# Access Audit Site Report

**Mission Tejas State Park**

**Accessibility Evaluation**

**Inspection Date: 09/14/2022**

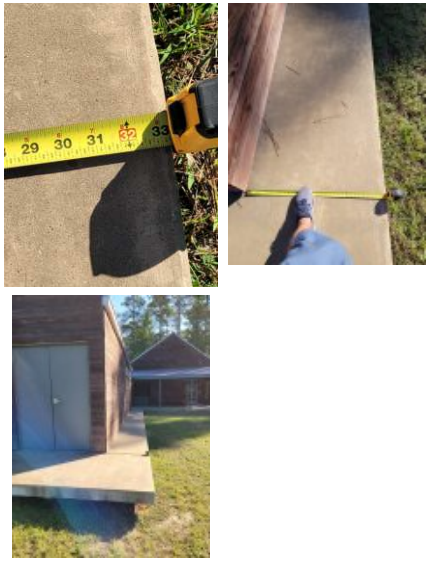
Finding Number	Area Description	Lat/Long	Finding	As Built	Recommendation	Citation	Photos	Figure
6	Headquarters Area: HQ - Parking	[31.5425783, -95.23363]	The cross slopes (narrow dimension) and/or running slopes (long dimension) of the access aisle exceeds 2%. The running slope and the cross slope in an accessible parking stall and the access aisle must not exceed 2%.	Small lot at HQ - Aisle 3%, stall 3.5%	Repair or correct slope of parking space and access aisle to max 2.08% in any direction.	2015 ABAAS Section: 502.4 2012 TAS Section: 502.4 2010 ADAS Section: 502.4		
7	Headquarters Area: HQ - Exterior Accessible Route	[31.54194, -95.23346]	At least one accessible route shall connect accessible buildings, accessible facilities, accessible elements, and accessible spaces that are on the same site. For areas of sport activity, an accessible route is required to connect to the boundary of each area of sport activity. The size of an area of sport activity includes only the space needed to play. Where multiple sports fields or courts are provided, an accessible route is required to each field or area of sport activity.	Lacks AR to firewood building, step to enter	Provide an accessible route (AR) to each element within the site.	2010 ADAS Section: 206.2.2, 206.2

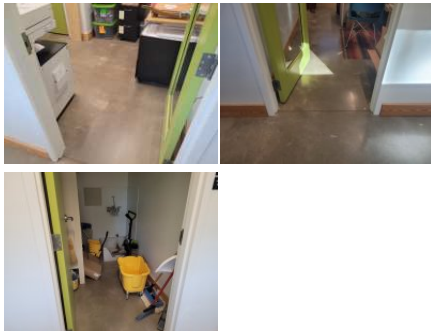
Finding Number	Area Description	Lat/Long	Finding	As Built	Recommendation	Citation	Photos	Figure
13	Headquarters Area: HQ - Exterior Accessible Route	[31.5422997, -95.2339521]	Stairways must have handrails on both sides. Handrails and their extensions must be between 34 inches and 38 inches above the stair nosing or ground. The top handrails shall extend a minimum of 12 inches beyond the top nosing and shall be parallel with the floor or ground surface. At the bottom of a stair flight, handrails shall extend at the slope of the stair flight for a horizontal distance at least equal to one tread depth beyond the last riser nosing. Extension shall return to a wall, guard, or the landing surface, or shall be continuous to the handrail of an adjacent stair flight. The orientation of at least one handrail, including the extension, shall be in the direction of the run of the stair and perpendicular to the direction of the stair nosing. Handrail gripping surfaces with a circular cross section shall have an outside diameter of 1-1/4 inches minimum and 2 inches maximum. Handrail gripping surfaces with a non-circular cross section shall have a perimeter dimension of 4 inches minimum and 6 1/4 inches maximum, and a cross-section dimension of 2-1/4 inches maximum. The hand grip portion of handrails shall have a smooth surface with no sharp corners. Gripping surfaces (top or sides) shall be uninterrupted by newel posts, other construction elements or obstructions. Any wall or other surface adjacent to the handrail shall be free of sharp or abrasive elements. Handrails projecting from a wall shall have a space of 1-1/2 inches minimum between the wall and the handrail.	Lacks handrails at steps from camping entry parking	Install handrails on both sides of stairway, mounted 34" to 38" AFF with top and bottom extensions and having a 1.25" – 2" in diameter, or a non-circular grip that has a perimeter dimension of 4"- 6.25" max with a min gap of 1.5" between handrail and wall	2015 ABAAS Section: 505.2 2012 TAS Section: 505.2 2010 ADAS Section: 505.2

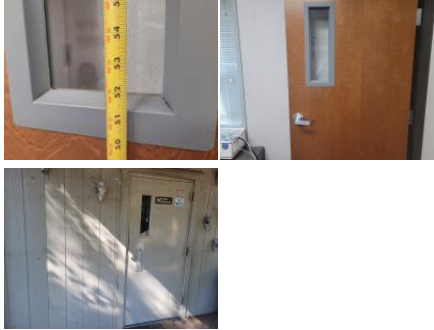
47	Headquarters Area: HQ - Visitors Center	[31.5419, -95.2338]	The top of the work surface is not within a compliant height range. The tops of tables and counters shall be 28 inches to 34 inches from the floor or ground.	Main room - table has 26.5" knee clearance	Provide tables and work surfaces at 28" to 34" AFF with required knee and toe clearances.	2015 ABAAS Section: 902.3 2012 TAS Section: 902.3 2010 ADAS Section: 902.3		
48	Headquarters Area: HQ - Visitors Center	[31.5419, -95.2338]	The threshold at a doorway shall be no higher than 1/2 inch. Changes in level between 1/4 inch and 1/2 inch must be beveled at 1:2 or less. 1/4 inch is the maximum vertical rise. Exterior doors are recommended to be maintained at 8.5 lbf as a smart practice. Force is to be measured at the operating hardware or 30 inches from the hinges, whichever is greater.	Visitors center entry - 15 lbf, 20 lbf, 1.5" lipped threshold	For all doors along the public circulation route, provide beveled threshold. For all doors along the public circulation route, inspect, adjust, and maintain 8.5 lbf to open exterior doors as a smart practice.	2010 ADAS Section: 404.2.3, 404.2.7, 404.2.4, 404.2.11, 404.2.11 Exception

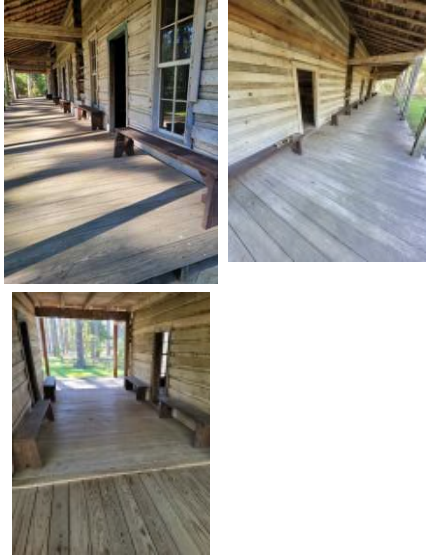
105	Day Use Area: Rice Family Log Home	[31.54307, -95.23286]	Element meets all standards and requirements	Rice Family Home- lot meets scoping - 1 accessible, 3 standard	None	2010 ADAS Section: N/A

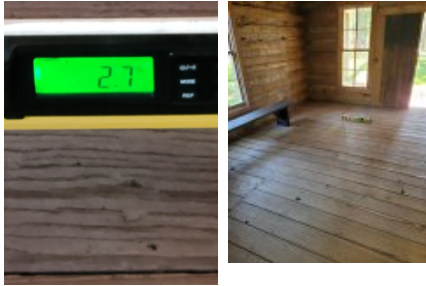
Finding Number	Area Description	Lat/Long	Finding	As Built	Recommendation	Citation	Photos	Figure
112	Day Use Area: Rice Family Log Home	[31.5428534 , -95.232950 1]	Element meets all standards and requirements	16 of 16 benches compliant	None	2010 ADAS Section: N/A		
113	Day Use Area: Rice Family Log Home	[31.5428877 , -95.232979 3]	The ramp slope exceeds the maximum running slope (direction of travel) allowable of 8.33%. Ramps should have the least possible slope but in no case more than 8.3% (1:12).	Entry Ramp - 12% on ramp	Correct slope of ramp to max 8.33%.	2015 ABAAS Section: 405.2  2012 TAS Section: 405.2  2010 ADAS Section: 405.2		
114	Day Use Area: Rice Family Log Home	[31.5429106 , -95.23299]	The landing is not the correct length. Landings shall have a dimension in the direction of ramp run of not less than 60 inches.	Entry Ramp - Lacks landing and route	Enlarge landing to be 60" deep and as wide as the ramp and connect to an accessible route.	2015 ABAAS Section: 405.7.3  2012 TAS Section: 405.7.3  2010 ADAS Section: 405.7.3

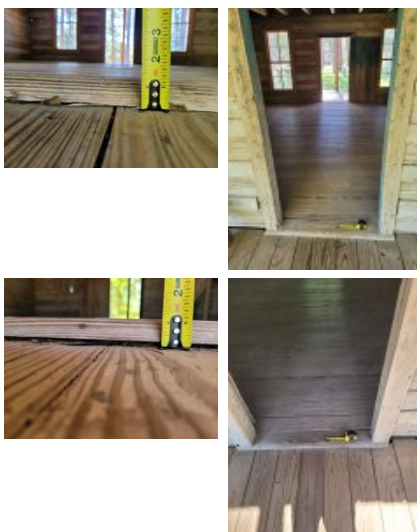
Finding Number	Area Description	Lat/Long	Finding	As Built	Recommendation	Citation	Photos	Figure
122	Day Use Area: Rice Family Log Home	[31.5428263 , -95.232977]	The accessible route contains running slopes greater than 5 percent and cross slopes greater than 2 percent across the width of the walk and has not been constructed as a ramp (i.e. handrails, wheel guides, etc.). When the slope in the direction of travel of any walk exceeds 1 unit vertical in 20 units horizontal (5-percent slope), it must be constructed as ramp. Surface cross slopes must not exceed one unit vertical in 48 units. Horizontal (2-percent slope).	First room - 2.7% cross slope near doorway	Correct or repair slope to max 2.08% cross.	2015 ABAAS Section: 403.3  2012 TAS Section: 403.3  2010 ADAS Section: 403.3		
123	Day Use Area: Rice Family Log Home	[31.5428251 , -95.232964 9]	Openings in floor or ground surfaces shall not allow passage of a sphere more than 1/2 inch (13 mm) diameter except as allowed in 407.4.3, 409.4.3, 410.4, 810.5.3 and 810.10. Elongated openings shall be placed so that the long dimension is perpendicular to the dominant direction of travel.	First room - gaps of 2" at fireplace, 1" near bench	Fill and maintain gaps to max .5".	2015 ABAAS Section: 302.3  2012 TAS Section: 302.3  2010 ADAS Section: 302.3

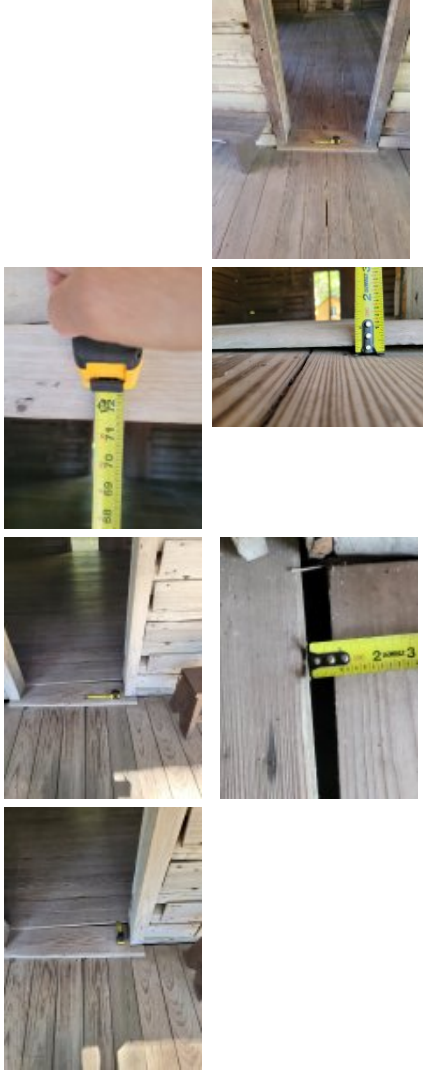
126	Day Use Area: Rice Family Log Home	[31.5428374 , -95.232966 4]	Openings in floor or ground surfaces shall not allow passage of a sphere more than 1/2 inch (13 mm) diameter except as allowed in 407.4.3, 409.4.3, 410.4, 810.5.3 and 810.10. Elongated openings shall be placed so that the long dimension is perpendicular to the dominant direction of travel.	Middle room - gap of 1.5" at fireplace	Fill and maintain gaps to max .5".	2015 ABAAS Section: 302.3  2012 TAS Section: 302.3  2010 ADAS Section: 302.3

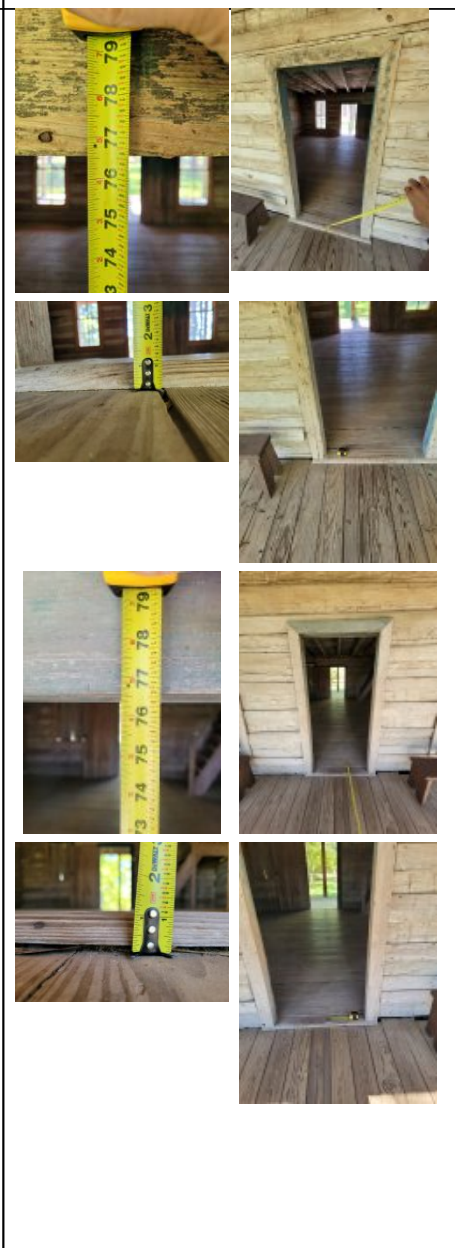
129	Day Use Area: Rice Family Log Home	[31.5428466 , -95.232950 3]	There is a gap spaced greater than a 1/2 inch. Openings in floor or ground surfaces shall not allow passage of a sphere more than 1/2 inch diameter. Elongated openings shall be placed so that the long dimension is perpendicular to the dominant direction of travel.	Parking lot side porch - 1.75" gap approaching back room	Correct or fill gaps to be max .5".	2015 ABAAS Section: 302.3  2012 TAS Section: 302.3  2010 ADAS Section: 302.3

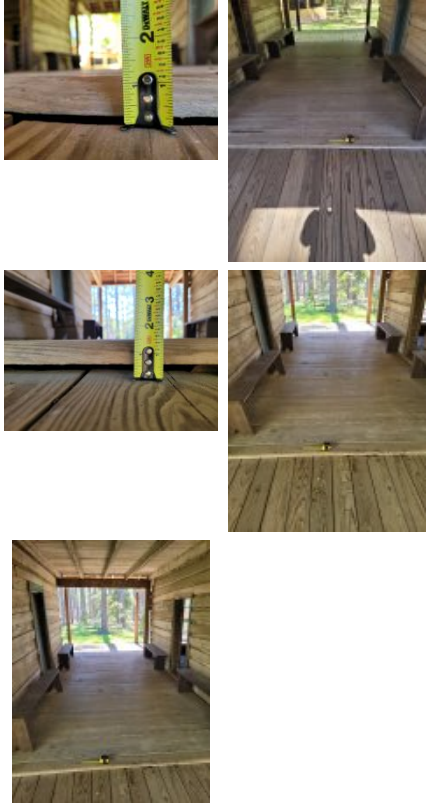
132	Day Use Area: Rice Family Log Home	[31.5427949 , -95.232971 5]	Door openings shall provide a clear width of 32 inches (815 mm) minimum. Clear openings of doorways with swinging doors shall be measured between the face of the door and the stop, with the door open 90 degrees. Openings more than 24 inches (610 mm) deep shall provide a clear opening of 36 inches (915 mm) minimum. There shall be no projections into the required clear opening width lower than 34 inches (865 mm) above the finish floor or ground. Projections into the clear opening width between 34 inches (865 mm) and 80 inches (2030 mm) above the finish floor or ground shall not exceed 4 inches (100 mm). The threshold has a gap greater than 1/2 inch wide. The threshold at a doorway shall be no higher than 1/2 inch. Changes in level between 1/4 inch and 1/2 inch must be beveled at 1:2 or less. 1/4 inch is the maximum vertical rise.	Back room - ramp side - 30.5" width, 62" overhead, 1" CIL at threshold; middle door - 29.75" width, 69.85" overhead, 1.25" CIL at threshold; other side - 71.5" overhead, 1.25" CIL and .75" gap at threshold	For all doors along the public circulation route, replace doors with doors having 80" overhead clearance and 32" clear width. For all doors along the public circulation route, fill gaps at door entries to max .5". For all doors along the public circulation route, provide beveled threshold.	2010 ADAS Section: 404.2.3, 404.2.7, 404.2.4, 404.2.11, 404.2.11 Exception

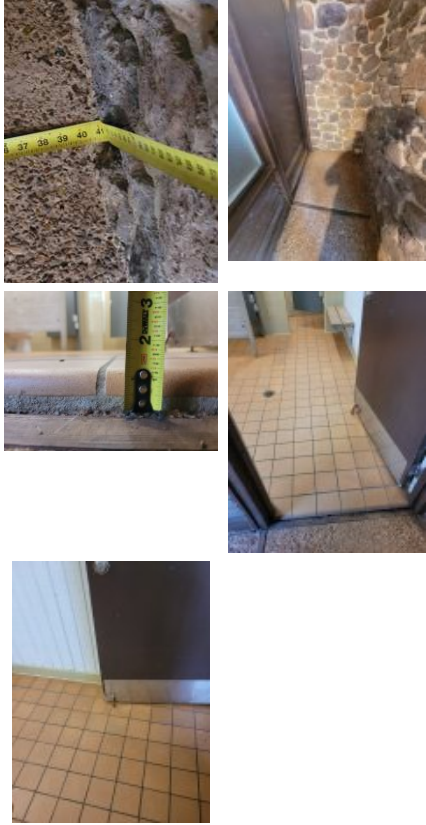
174	Main Camping Loop (Campsites 1-15): Commemorative Mission	[31.54823, -95.23997]	There is a change in level greater than 1/4 inch. 1/4 inch is the maximum vertical rise. Changes in level between 1/4 inch and 1/2 inch must be beveled at 1:2 or less. Changes in level greater than 1/2 inch must be by way of a ramp.	Stone floor has CILs and gaps	Replace stone floor or provide a smooth pathway through the building if doing so would not effect the historic significance of the building.	2015 ABAAS Section: 303.3 2012 TAS Section: 303.3 2010 ADAS Section: 303.3
